OSE Reference: 24070

Re: MCU for a tourist park on Fichera Road Mareeba for R & M Patane – MSC request for information – MCU/23/0021.

We refer to Mareeba Shire Council's RFI dated 3rd November 2023, which requested a traffic impact assessment to determine whether the additional traffic generated by this proposal, would have any significant impact on road safety for the users of Fichera Road.

PROJECT: 49 FICHERA RD MAREEBA 4880	DATE: FEB 2023 SCALE: AS SHOWN ON 'A3' SHEET DRAWING TITLE: PROPOSED OVERALL SITE
PROPOSED TOURIST PARK	JOB NO. SHEET No. ISSUE 0744 DA 01 C

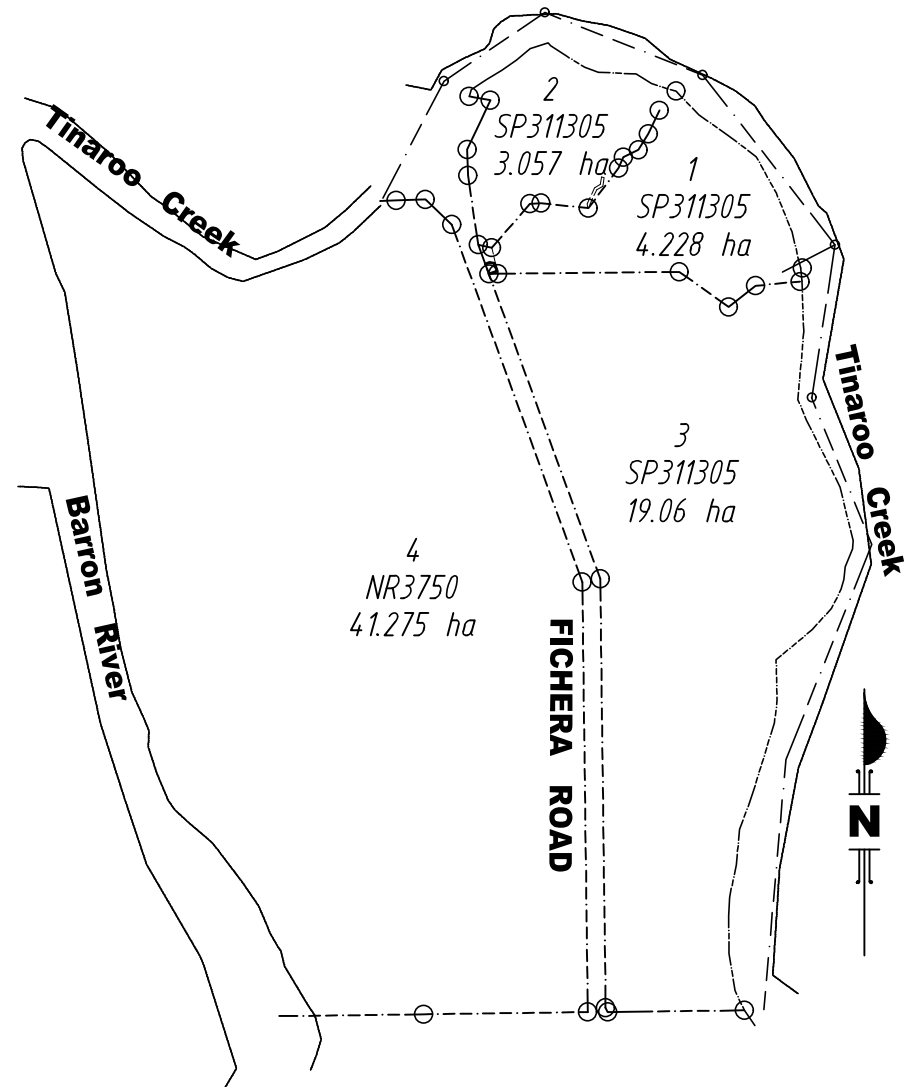
The project includes the provision of 16 camping sites located in 5 separate areas, four of these will be served by 1 access to Fichera Road and the remaining site served by a separate access located approximately 275 metres apart. The overall site and access locations are shown on the attached site plan.

Standard Drawing
S1105

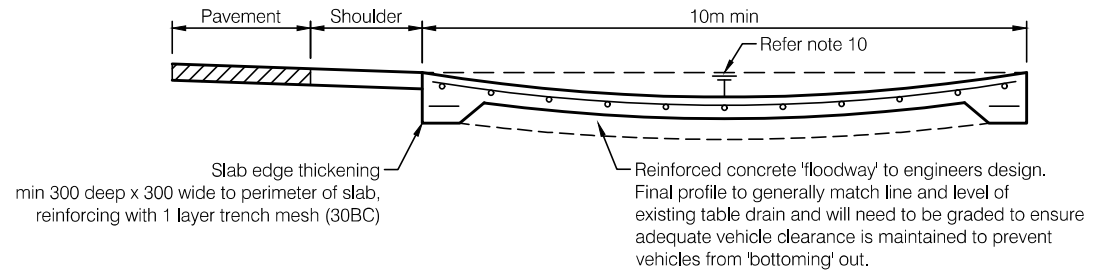
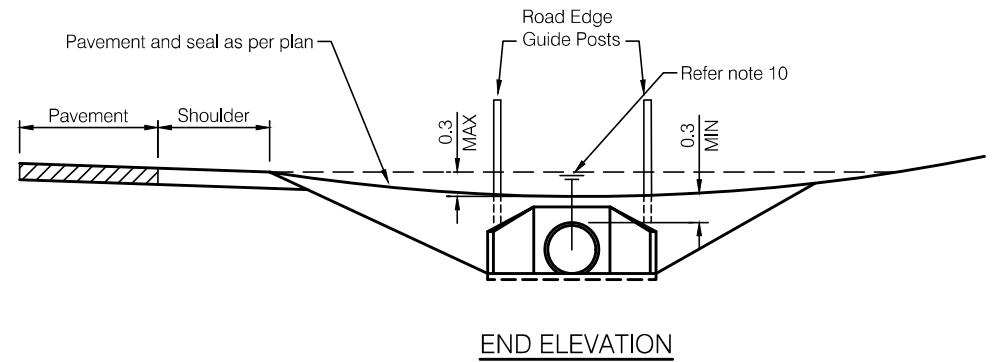
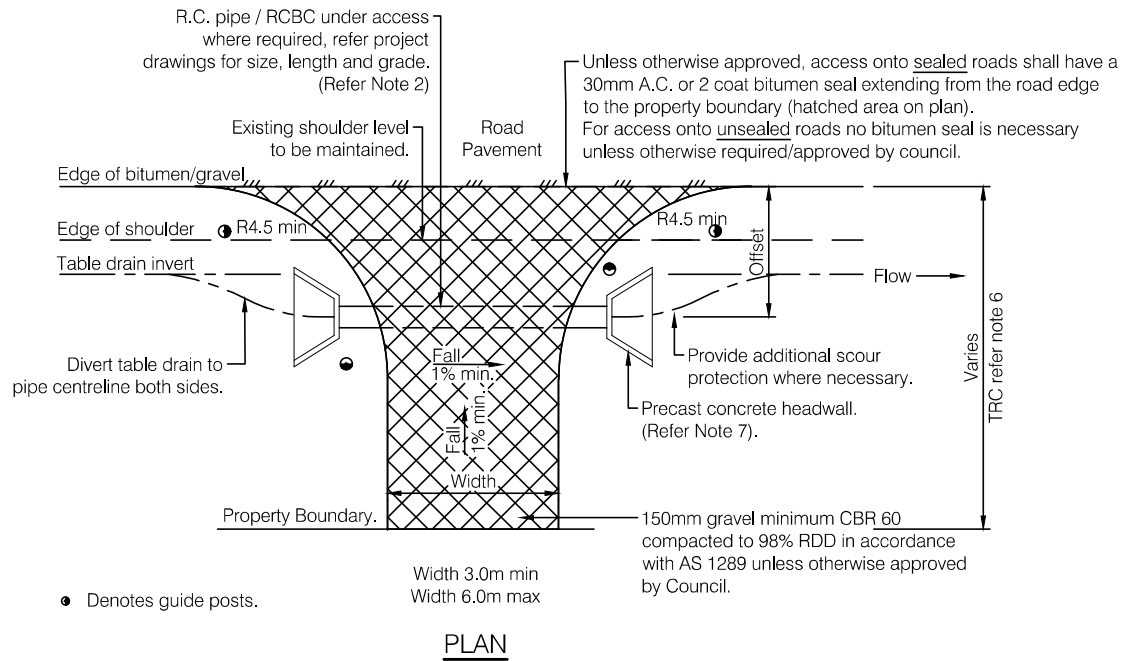
On this basis there are no safety issues on Fichera Road, and no upgrading works are required. However, for safety reasons and controlled turning of vehicles from Fichera Road into the two access points we recommend that these accesses should be upgraded to provide a sealed entry from the edge of the bitumen seal to the property boundary. Provision should be made for culverts or causeways to accommodate stormwater flows along Fichera Road if required. These accesses should be constructed in accordance with FNQROC drawing S1105 with a minimum entry width of 4 metres. A copy of the relevant drawing is attached.
